DEVELOPMENT REVIEW BOARD REPORT

MEETING DATE: June 9, 2005

CASE NUMBER/ PROJECT NAME	12-DR-2005 104th and Bell; Community Park and Building		
LOCATION	Thompson Peak Parkway & Bell Road		
REQUEST	Request approval of a site plan and elevations for the community park and buildings for 104 th Street/Bell Road Master Planned Community (Windgate Ranch).		
OWNER	Toll Brothers 480-595-1945	ENGINEER	Gilbertson & Associates 480-607-2244
ARCHITECT/ DESIGNER	Douglas Fredrikson Architects 602-277-1625	APPLICANT/ COORDINATOR	Rich Schoonmaker Toll Brothers 480-595-1945
BACKGROUND	<p>Zoning/History.</p> <p>In May 2004, the Development Review Board approved the preliminary subdivision plat for the master planned community at 104th Street and Bell Road (Windgate Ranch; Case 9-PP-2004). In March 2004, the Development Review Board approved the Master Environmental Design Concept Plan (MEDCP; Case 1-MP-2004). Also in 2004, the City entered into a Development Agreement to resolve development issues and issues related to the City's acquisition of 383 acres for the McDowell-Sonoran Preserve (DA# 2004-026-COS, amended).</p> <p>In 1991, this 780-acre property was rezoned as part of a master planned commun

COURTYARD ELEVATIONS

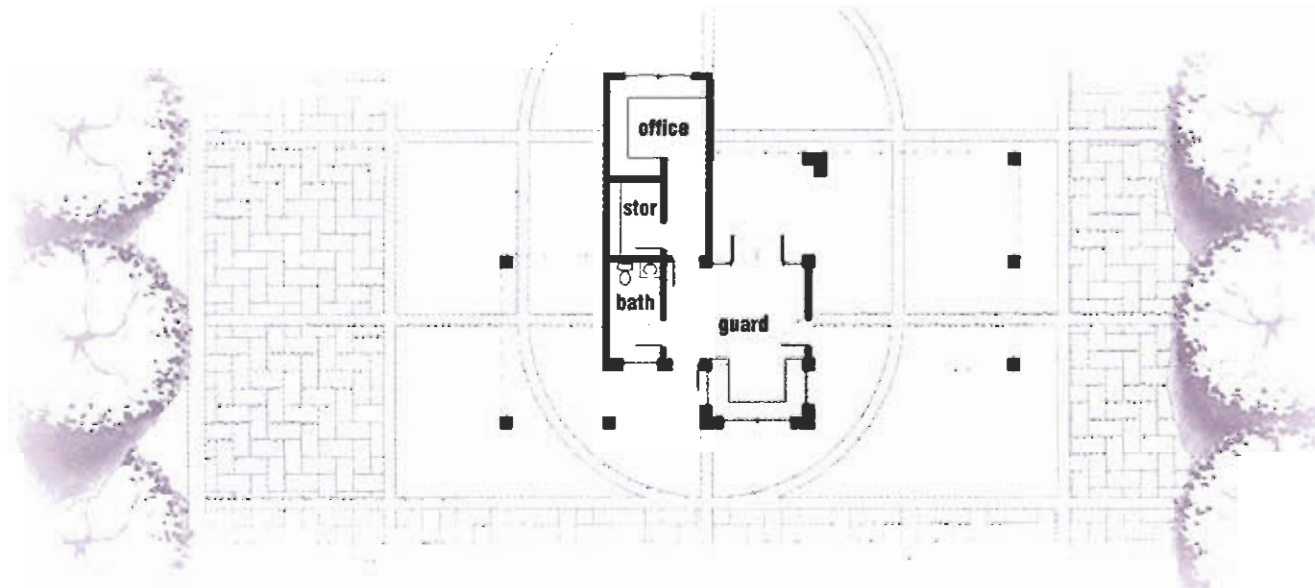
- a. Architectural elements, including dimensions, materials, form, color, and texture, shall be constructed to be consistent with the building elevations submitted by Douglas Fredrikson Architects with a city receipt date of 4/19/2005.

Toll Brothers, Inc.
Windgate Ranch @ Scottsdale - Community Park
Wall Plan
Scottsdale, AZ

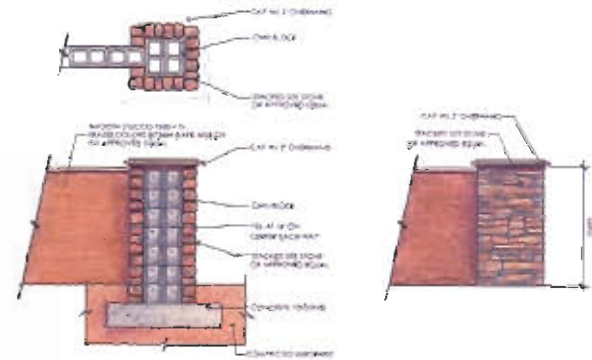
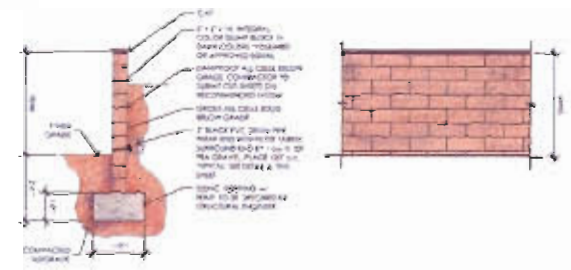
- e. Wall heights shall be consistent with the Wall Plan submitted by Greey/Pickett with a city receipt date of 4/19/2005.

- 8' Blue/Pedestrian Path (Public)
- 8' Multi-Use Path (Private)
- 5' Blue/Pedestrian Path (Private)
- 4' Trail (Private)
- Interceptor Path (5' Typical)
- Non-Marked Cross Walk Location
- Handicap Ramp Location

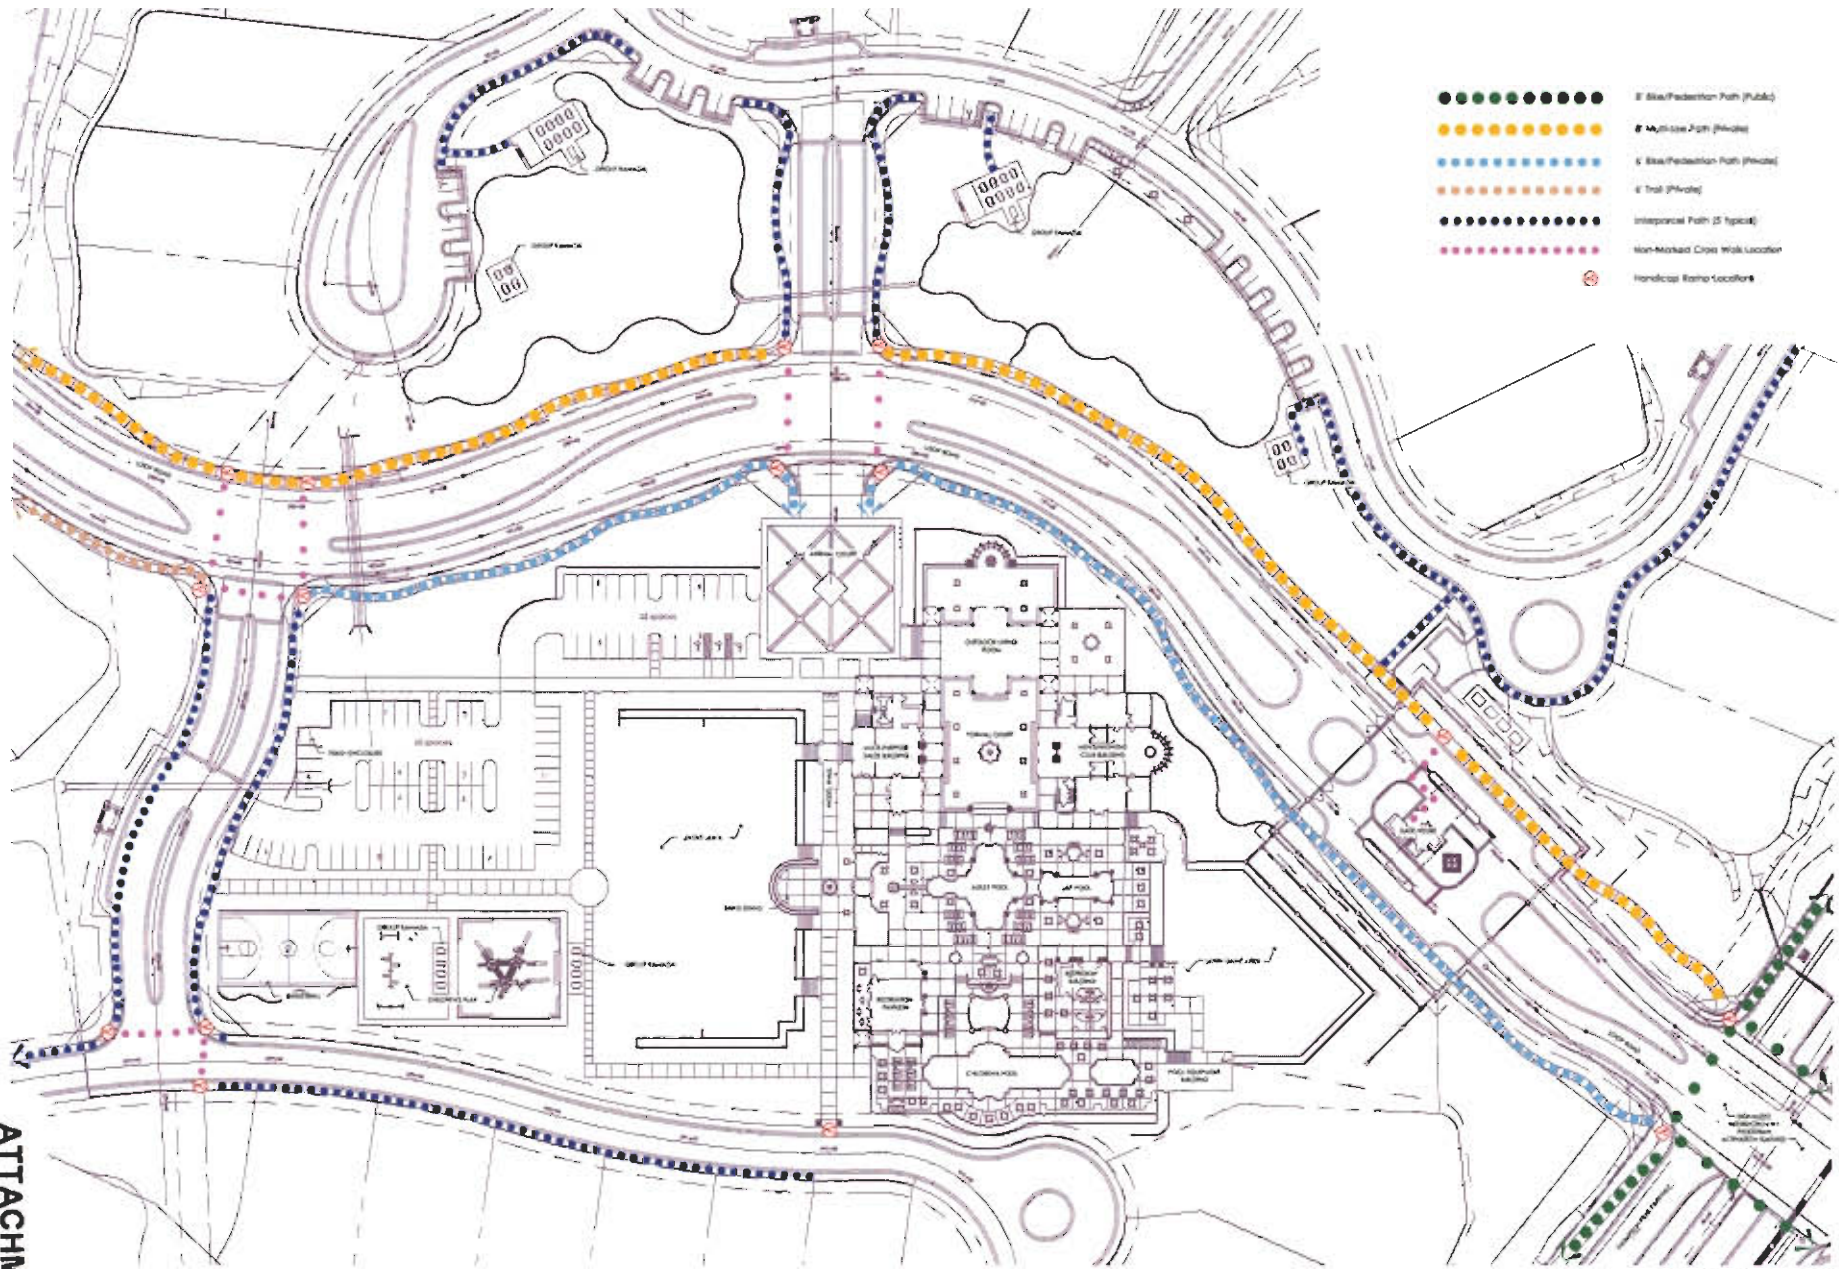
- d. The location and configuration of all pedestrian connections shall be shown on the site plan to be consistent with the Pedestrian Connections plan submitted by Greey/Pickett with a city receipt date of 4/19/2005.
